Office Action Summary

09/733,302

DETAILED ACTION

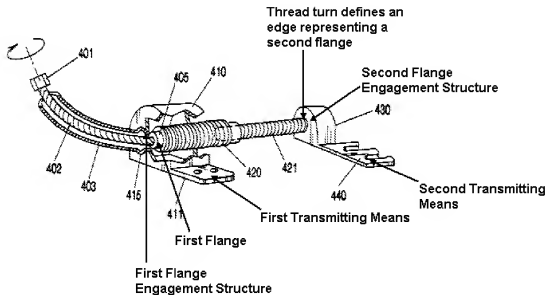
Applicant's arguments with respect to the rejections over Landsberger are not persuasive for the following reasons. As illustrated in marked up Fig. 4B on the following page, Landsberger discloses the first transmitting means to have a first flange engagement structure, the second transmitting means to have a second flange engagement structure, and the expansion means to have a first flange 405 that

engages the first flange engagement structure and a second flange that engages the second flange engagement structure.
